# Technical Service Information

## FORD AOD-E/4R70W CONVERTER CLUTCH SHUDDER

**NEW DESIGN LEVEL TORQUE CONVERTER NOW AVAILABLE  
WITH 7/8" LARGER DIAMETER CLUTCH PLATE.**

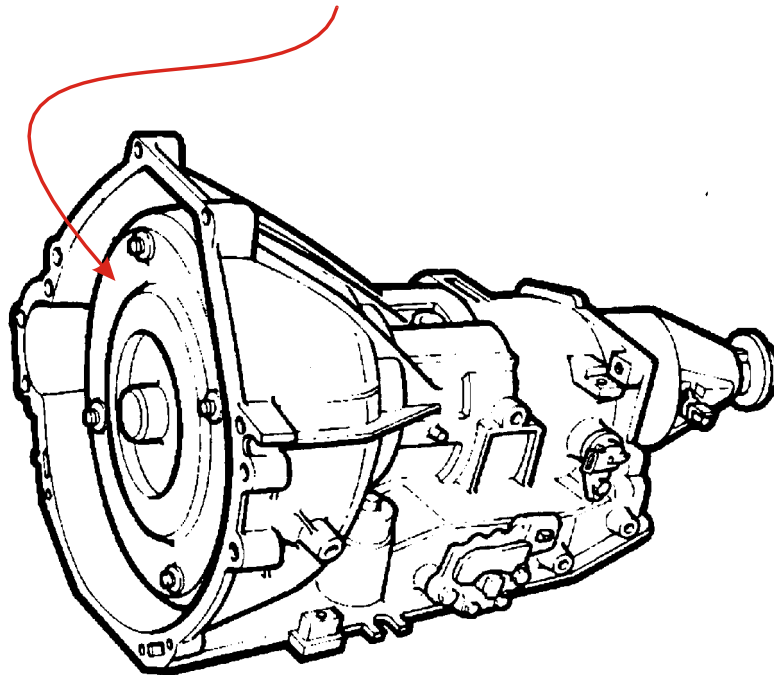
**COMPLAINT:** Some 1992- 1995 vehicles equipped with the AODE/4R70W transmission may exhibit a converter clutch shudder or vibration, during light to moderate acceleration, and may occur on the apply and/or the release of the converter clutch.

**CAUSE:** The cause may be, insufficient diameter of the converter clutch.

**CORRECTION:** There is now available from Ford Motor Company, new design level converters for the AODE/4R70W transmissions, that have an increased diameter converter clutch plate (Approx. 7/8" Larger), that will eliminate the condition above. Refer to the chart shown in Figure 2, for the proper part number for your application. *Note:* Refill transmission with MerconO Automatic Transmission Fluid (Part No. XT-2-QDX), when refilling to ensure proper fluid quality is being used.
